**Service information**

**Reference no.: SDA\_100186**

Brew unit is hard to remove

Image 1

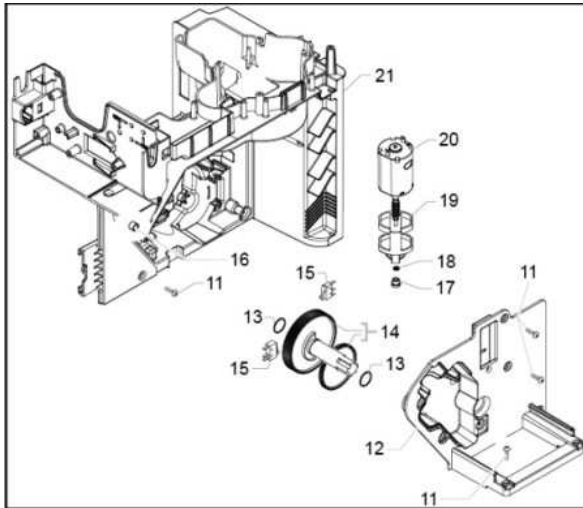
The customer complain that the brew unit is hard to remove. It can happen that while removing the brew unit, parts of the brew unit or the holder can be broken.

Up to S/N TW901326365961 change the black ratiomotor mounting plate cover with a new one (part N°12 in Image 1 cod.996530073444 - 17001839).

From S/N TW901326365962 the black ratiomotor mounting plate cover has been modified to improve the inserting and the removing of brew unit.
